Memorandum

Subject: Comments on *Comprehensive Summary of Site Conditions Report, 1700 Jefferson, Oakland, CA, November 2017, Prepared by Applied Water Resources (Fuel Leak Case No. RO0000151)*

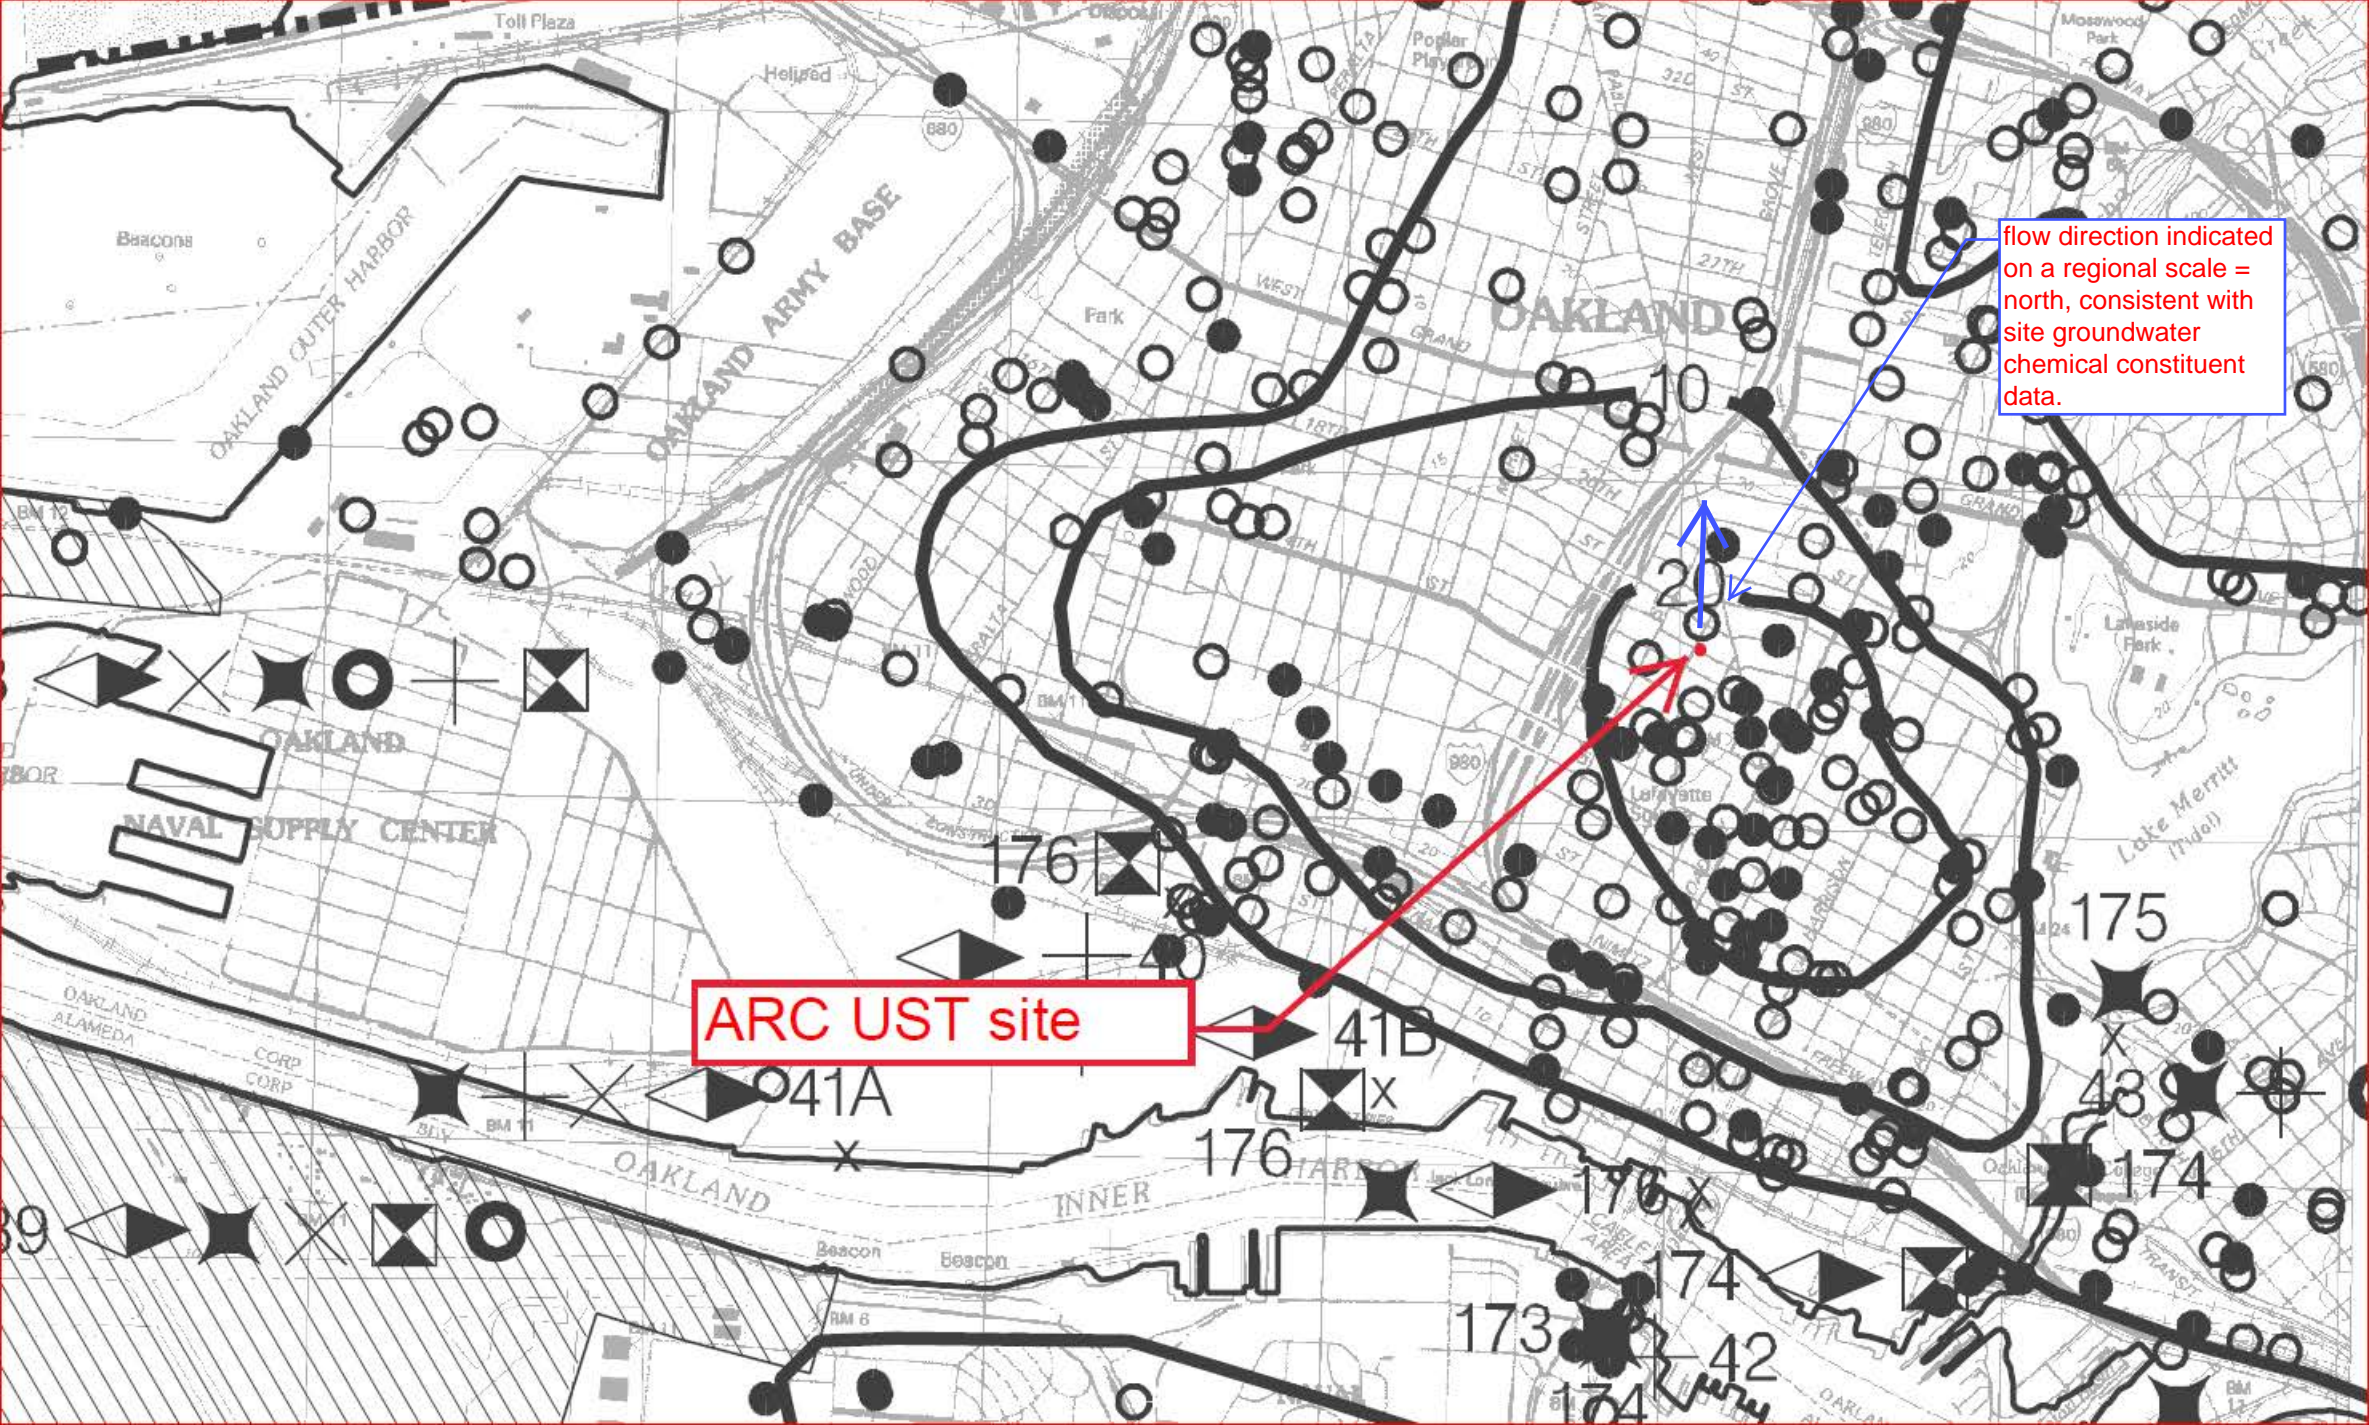
The six monitoring wells at the site represent an extremely small area of measurement in comparison to regional groundwater flow data. Such a small network cannot be relied upon to definitively tell which way groundwater is flowing on a regional basis. The attached map, taken from the California Geological Survey's Seismic Hazard Zone report for the Oakland West Quadrangle (CGS, 2003) shows a summary of the maximum depth to water data from hundreds of wells reported by the Department of Water Resources for the Oakland area. The six monitoring wells from the site cover the area of a pin head on a regional basis. This map also indicates that the predominant groundwater flow direction at the site is to the north, which is consistent with the other lines of evidence we have including, most importantly, the groundwater concentration data itself. The variations measured in flow direction over time at the ARC site are more likely the result of data quality problems with the readings, the wells themselves, or temporal effects from localized pumping from building excavations as documented in Harding Lawson's Corrective Action Plan (HLA, 1997), or by historic pumping from the two wells documented in the report (page 7).

flow direction indicated on a regional scale = north, consistent with site groundwater chemical constituent data.
